**Addendum No. 1
January 23, 2018**

Project: CBEC Roof Replacement
South Dakota School of Mines & Technology
Rapid City, South Dakota
OSE #R0718 – 02X
Architect's Project #2735

Architect: Architecture Incorporated

DRAWING
SD-1

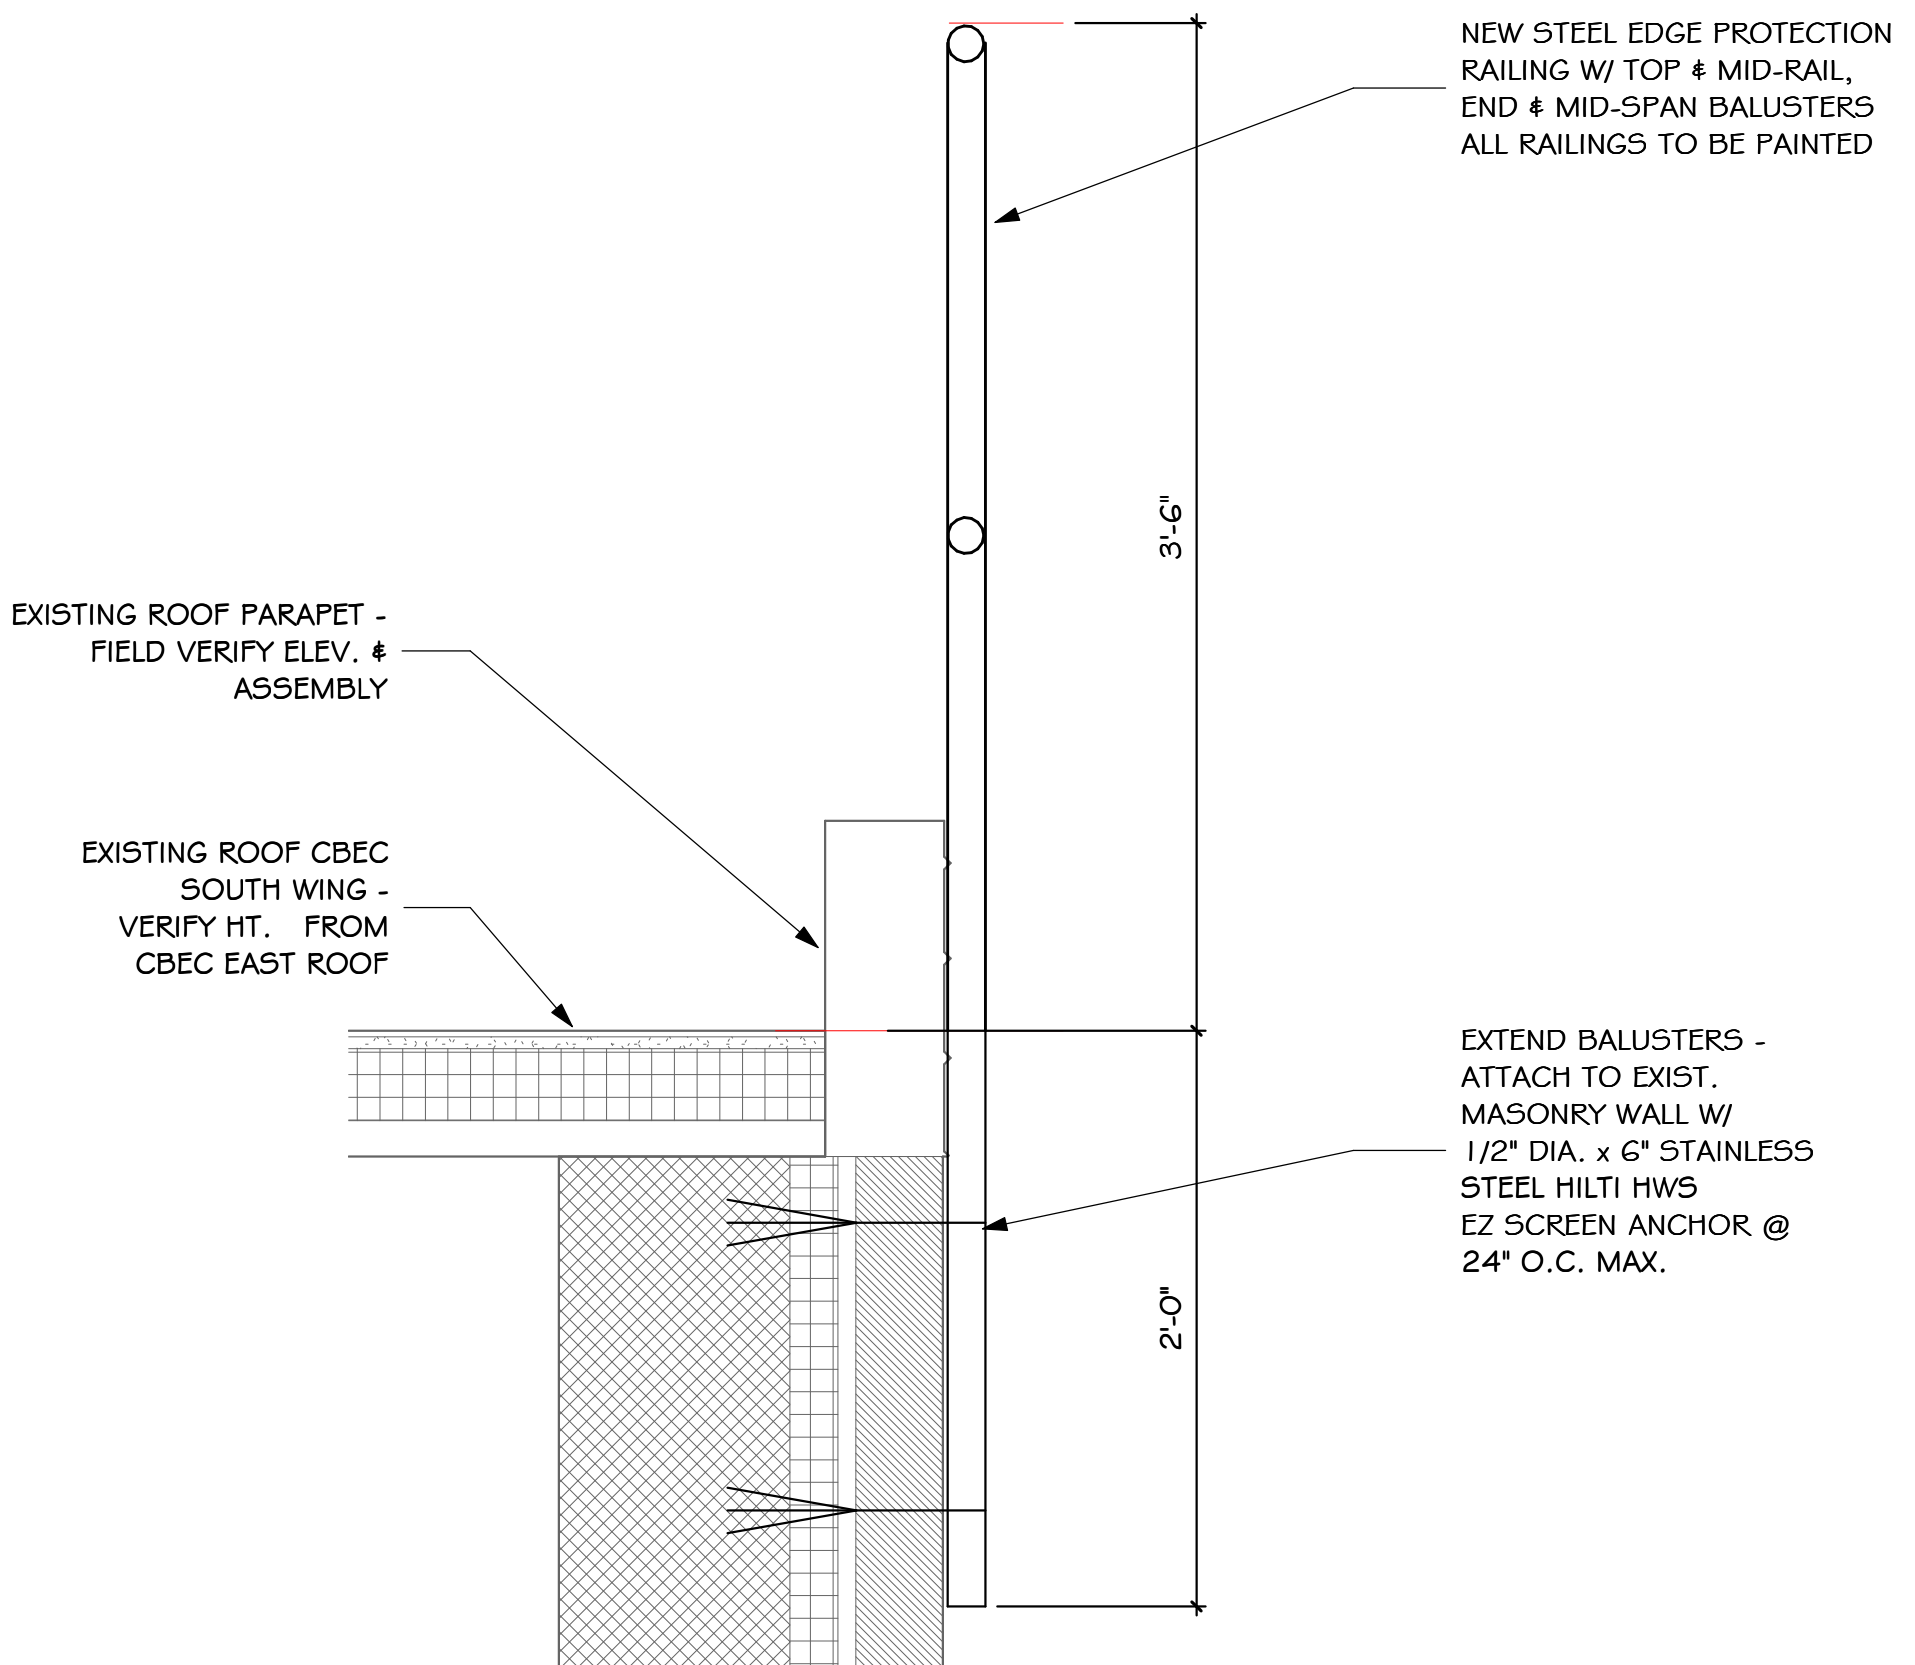
- a) See attached Supplemental Drawing SD-1: Duct Penetration Detail for the duct roof penetration conditions without existing metal flashings. There are approximately 10 such locations; contractor field verify exact number and sizes.
- b) Detail 8/5.54 – Roof Edge Railing: the railing was not visible in the detail. See attached Supplemental Drawing SD-2 for Revised detail, showing the railing.
- c) See attached supplemental Drawing SD-3: South Mech Unit Curb for the flashing detail at the largemain rooftop mechanical unit located in the southeast roof quadrant. This detail addresses the existing base flashing of the RTU that is integral with the unit and can not be moved.

DUCT PENETRATION DETAIL

SOUTH MECH UNIT CURB

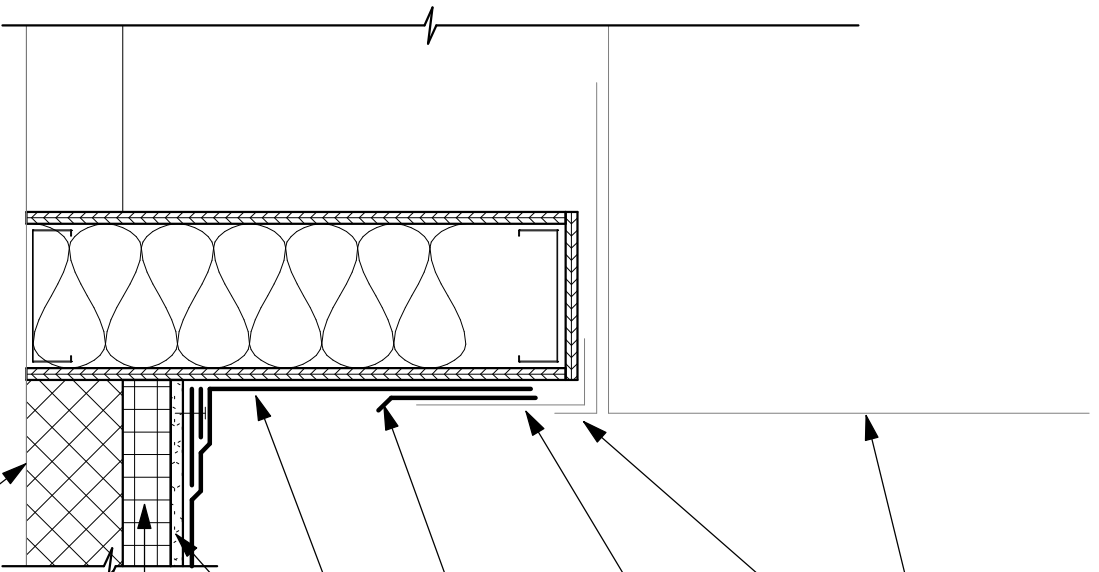
- g. Architect will issued modified detail drawing for flashing the curb of the large roof unit.

TOP 6" EXISTING EPDM TO REMAIN -
LOOSEN & EXTEND NEW COATED METAL
FLASHING & PVC MEMBRANE UNDER EPDM.
SEAL PVC & EPDM AS PER MNFR. DETAILS

NEW COATED METAL COUNTERFLASHING-
EXTEND UNDER EXIST EPDM FLAP

MEMBRANE FLASHING EXTENDED
UNDER NEW METAL COUNTERFLASH
